DR-PH-172

Project: Palen Solar Power Plant

Document Title: Schematic Process Flow Diagram

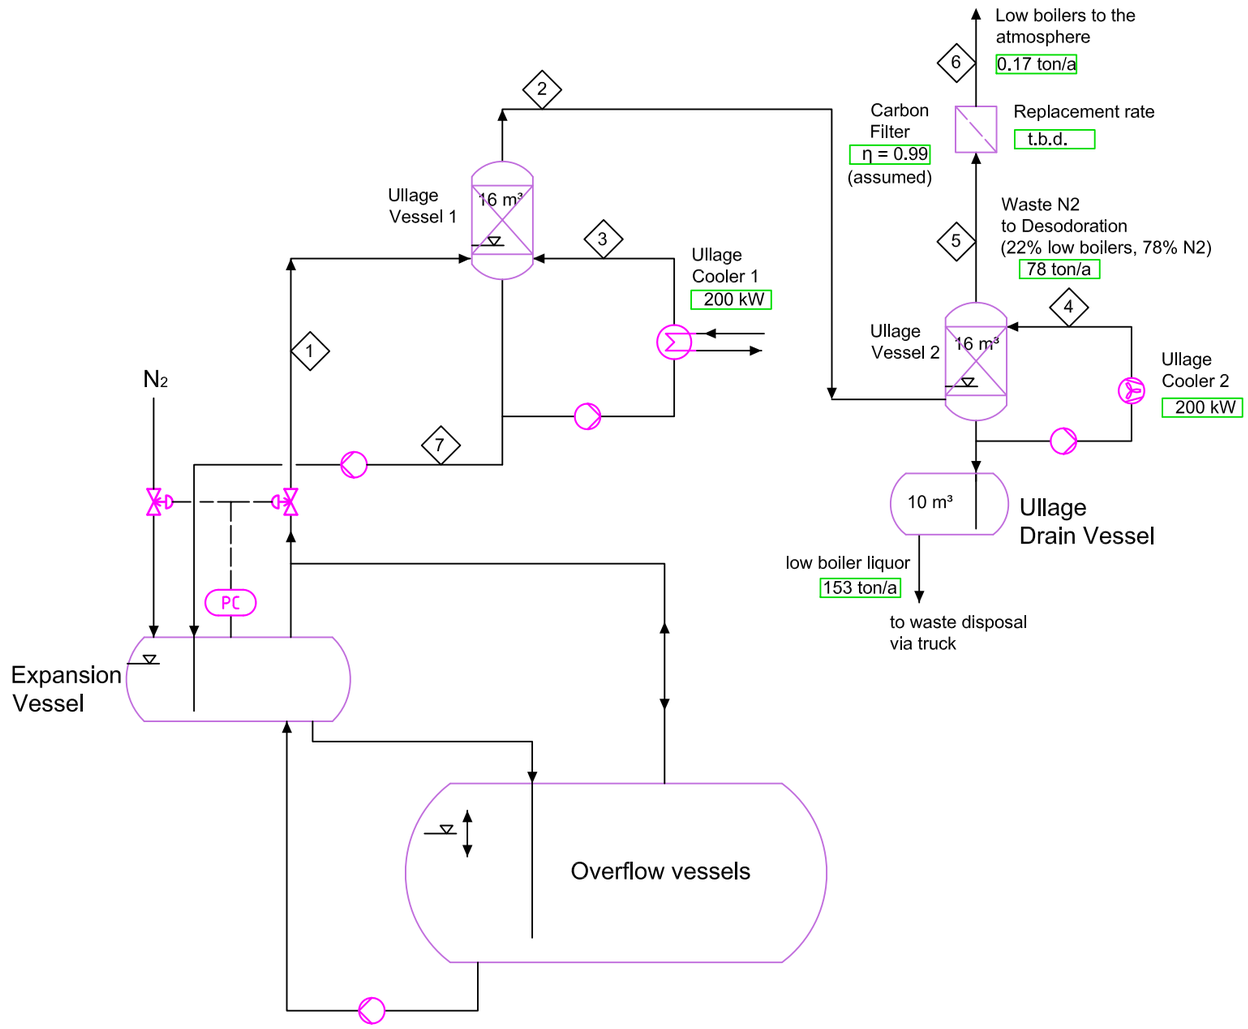
Please provide the Kramer Junction Solar Energy Generation facility data used in the AFC, specifically emission rates of benzene and other HTF thermal degradation products emitted.

A health risk assessment based on 137 pounds of VOC emissions per MW per year is incorporated into the public health risk impacts presented in the response to data request DR-PH-174, which identifies the individual contribution of HTF emissions to the total health risk posed by operation of the proposed power plant. Because benzene is the most toxic of the species reported, and the most likely compound to be emitted due to its chemistry, the operational health risk assessment was revised assuming the increase in VOC emissions would be comprised entirely of benzene to ensure that the health risk estimates were not underestimated. A copy of the WorleyParsons e-mail, Solutia e-mail, the relevant page of the Nevada Solar One permit and the Flagsol material balance diagram and process description are provided in Attachment DR-PH-176.

The HTF (Eutectic mixture of diphenyl oxide and diphenyl) degrades over time in low and high boiling products, which must be separated and eliminated from the cycle.
Low boiling degradation products are a mixture of benzene, toluene, xylene and phenol: the concentration of each component of the mixture can considerably differ from plant to plant and depends on many factors and is can be difficult to determine day-to-day concentrations. A high concentration of low boilers in the HTF changes the fluid properties and increase risk of cavitation for the pumps. In order to limit this effect, a mixture of nitrogen, degradation gases and HTF vapour is vented from the expansion vessel and the overflow vessels. To maintain sufficient pressure within the HTF cycle, nitrogen is introduced in the expansion vessel.
The gaseous mixture of nitrogen, low boiling products and HTF from the expansion vessel enters the ullage system via first ullage vessel, which contains a certain level of HTF at any time. HTF vapour within the mixture is condensed and is re-circulated to the HTF cycle via ullage discharge pump. The HTF content of the first ullage vessel is cooled by recirculation via ullage circulation pump 1 and ullage air cooler 1.

Leaving the first Ullage vessel, residual mixture of gaseous nitrogen and low boiling products enters the second ullage vessel. The HTF content of the second ullage vessel is also cooled (by recirculation via ullage recirculation pump 2 and ullage air cooler 2). By cooling the hydrocarbons within the gaseous mixture will condense to a certain extend. Residual gaseous components are vented to atmosphere.
Mass of collected liquid residuals and vented gas will depend upon the final operating temperature, the previous day operation and the temperature of the system overnight.
To limit the concentration of high boiling degradation products in the HTF cycle, the high boilers can be removed from HTF in the reclamation system. Therefore a small flow of hot HTF is taken from the hot (and pressurized) main pipe which is leaving the solar field and transferred to the reclamation system. The hot HTF immediately vaporizes in the un-pressurized reclamation flash vessel. The so generated HTF vapour is transferred to the first ullage vessel (see above), condensed and returned back to the HTF cycle, the residual non-vaporizing high boilers are left behind in the reclamation flash vessel and collected by gravity in the reclamation drain vessel.
